# 1984 Corvette: Service Bulletin: Generator Noise (Moan) at Idle with Air Conditioning On

**Model and Year:** 1984 Corvette

**Source:** Chevrolet Dealer Service Bulletin

**Bulletin Number:** 84-151, Section 6D (VIy)

FIGURE 1

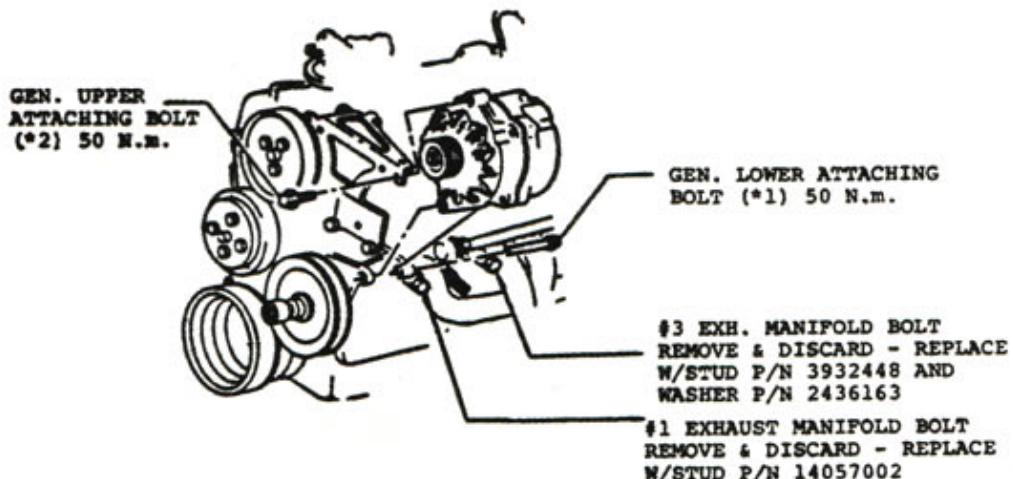
Some 1984 Corvettes may exhibit the subject noise, which is commonly defined as a "moan". This noise is induced into the generator by belt excitation when the air conditioning compressor is "on".

The following service procedure has been developed to reduce this noise by using three (3) new tubular braces and fasteners to replace the generator vibration period, which is the primary noise source.

1. Remove the generator rear support brace. Discard the support brace, attaching nut and attaching bolt.
2. Remove and discard #1 and #3 L.H. exhaust manifold to cylinder head attaching bolts (see Figure 1).
3. Install stud, P/N 14057002, in place of discarded #1 bolt and torque to 35 N.m.
4. Install stud, P/N 3932448, and washer, P/N 2436163, in place of discarded #3 bolt and torque to 35 N.m.

5. Remove the serpentine belt from the generator pulley.
6. Loosen generator attaching bolts (2). (See Figure 1).
7. Install three (3) tubular braces on the exhaust manifold studs as shown on Figure 2 and loosely retain with attaching nuts in three (3) places.
8. Install bolt, P/N 14066303, in longer single brace and bolt, P/N 14063755, in two (2) short braces. Loosely install bolts into generator housing (see Figure 2).

- Generator lower attaching bolt 50 N.m.
- Generator upper attaching bolt 50 N.m.
- Long tubular support brace to generator, attaching bolt 35 N.m.
- Two (2) short tubular support braces to generator, attaching bolt 50 N.m.
- Three (2) tubular support braces to three (3) exhaust manifold studs, 25 N.m. three (3) attaching nuts.
